Landscape Response to Appeal Scheme

Sheepwash Solar Energy Farm Appeal

April 2023

1.1.1. A Landscape and Visual Impact Assessment (LVIA) was prepared in February 2022 to accompany the planning application 22/501335/FULL for the proposed development on Land north of Little Cheveney Farm, Sheephurst Lane, Marden, Kent. The application was refused on 20th October 2022.

Fig
6

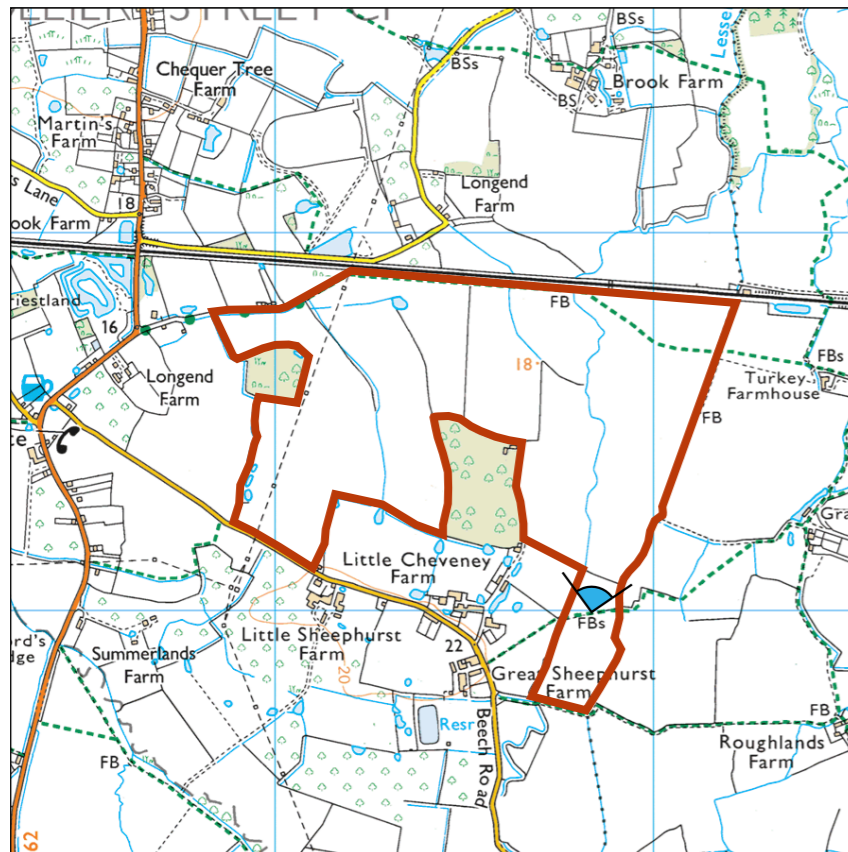
3.2.4. Viewpoints 2 and 3 have been updated to show the views with the removal of the BESS barn as shown on the revised viewpoints.

Viewpoint 3 (Appendix A, Figure 6) – from PROW. Looking north west. East of and 80m to the Site. High sensitivity receptor

- 4.8. The BESS barn would no longer be visible through the gap in vegetation, replaced by solar arrays further from the receptor through the gap in vegetation. The magnitude of change would reduce to medium with substantial adverse significance of effect upon completion.

- 4.9. With the gapping up of the field boundary vegetation with willow, poplar and alder (fast growing species) as well as a hedgerow that follows the fence line within 5-10 years the solar arrays would be substantially screened. The magnitude of change would improve to Medium beneficial with a Substantial Beneficial significance of effect

Client: Solar Century
 Project: **Sheepwash Solar Energy Farm, Marden**
 Drawing Title: Viewpoint 12 - Existing

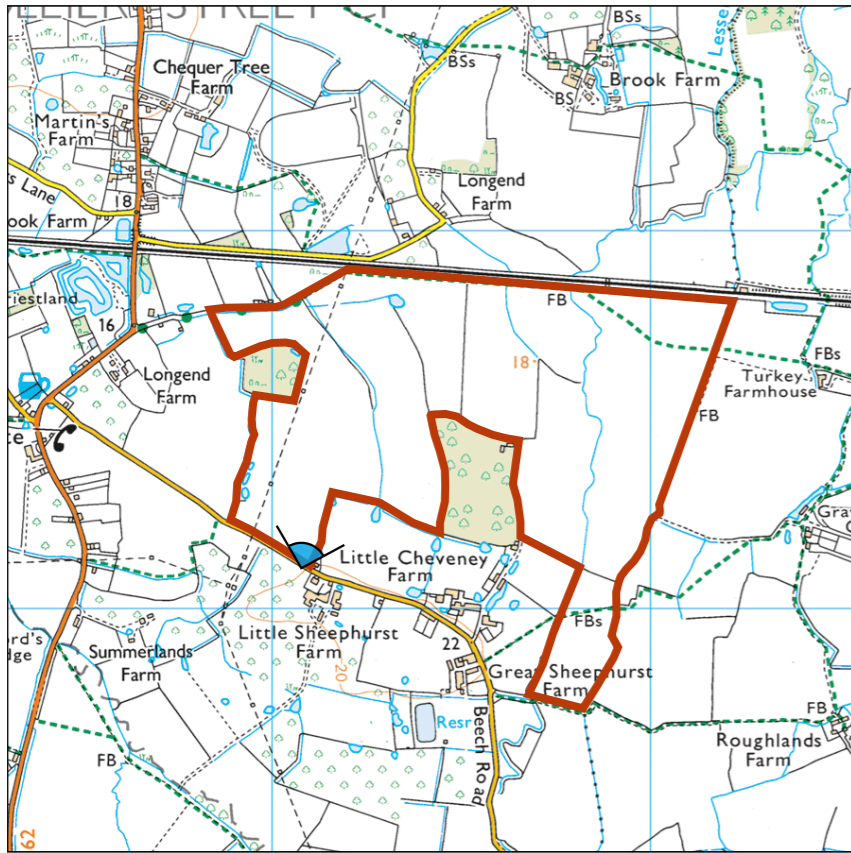
- *There will be industrialising visual impact of new gates which will be high and wide and set back behind a large bellmouth...There will be visual impact via the second farm gate access which will take some time to be screened from which will be visible the PV arrays and the industrialising HV compound.*

3.2.3. An additional viewpoint (Formerly a Plate) and montage was taken to the west of Viewpoint 10 (8 Sheephurst Cottages). This was in response to concerns over the visual amenity from this farm gate as raised within the Committee Report. This new viewpoint (Viewpoint 12) shows the Proposed Development and how it impacts this location.

Access is required and will be via gated access, which will be in accordance with highway requirements. The farm gate will be mitigated with infill. It is located on a 50mph road which is a transient view. However, this has been reassessed within this report, Viewpoint 12.

- 4.11. This is a new viewpoint (formerly Plate G) with montages (Appendix A, 7-11) and is west of 8 Sheephurst Cottages. This viewpoint has been prepared in response to the Committee Report. It is a winter view. The site is visible through a field gate along Sheephurst Lane. The road is a 50mph road with fast moving traffic and the view would be a transient view. The sensitivity of the receptor is classed as medium.

- 4.12. The construction of the site would be visible through the gate, as would the solar arrays and fenceline upon completion. However, this would be a transient oblique view. The magnitude of change would be medium with a Moderate Adverse significance of effect.

- 4.13. After 1 year, the woodland edge would reduce the magnitude of change to low with a Slight Adverse significance of effect. After 5-10 years the magnitude of change would be negligible, as the woodland would mature to screen the proposed development. The significance of effect would negligible.

Client: Solar Century
 Project: **Sheepwash Solar Energy Farm, Marden**
 Drawing Title: Viewpoint 13 - Existing

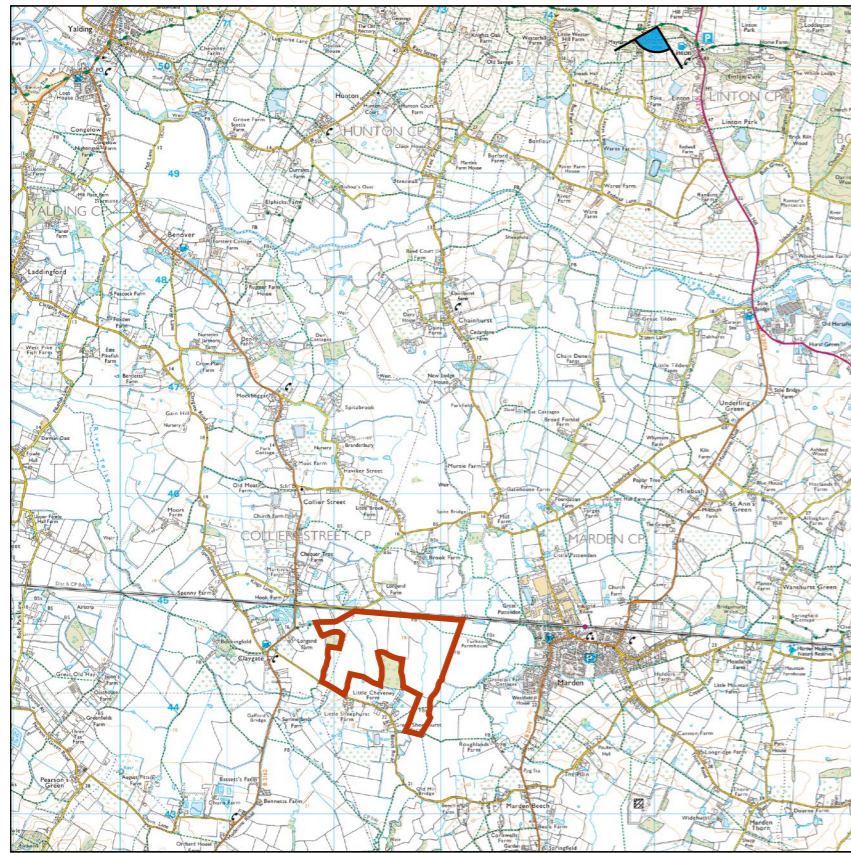
- *There is intervisibility between the site and the Greensand Ridge south of Coxheath and while there are polytunnels and some large scale horticultural/fruit packing buildings in the foreground, the solar farm would add to the industrialisation of the vista.*

Additional viewpoint assessed from the Greensand Ridge. See Viewpoint 13.

- 4.14. This is a new viewpoint with montages (Appendix A, Fig 12-16) and taken from The Greensand Ridge. This viewpoint has been prepared in response to the Committee Report. This viewpoint is taken from a PROW identified within the ZTV as having a potential view of the site. It is a high sensitivity receptor.

- 4.16. The magnitude of change during construction and upon completion would be negligible-nil with a negligible-nil significance of effect.
- 4.17. After 5-10 years the woodland would provide a mix of cover within the landscape, but would not significantly alter the view. The magnitude of change would remain negligible-nil with a negligible-nil significance of effect.
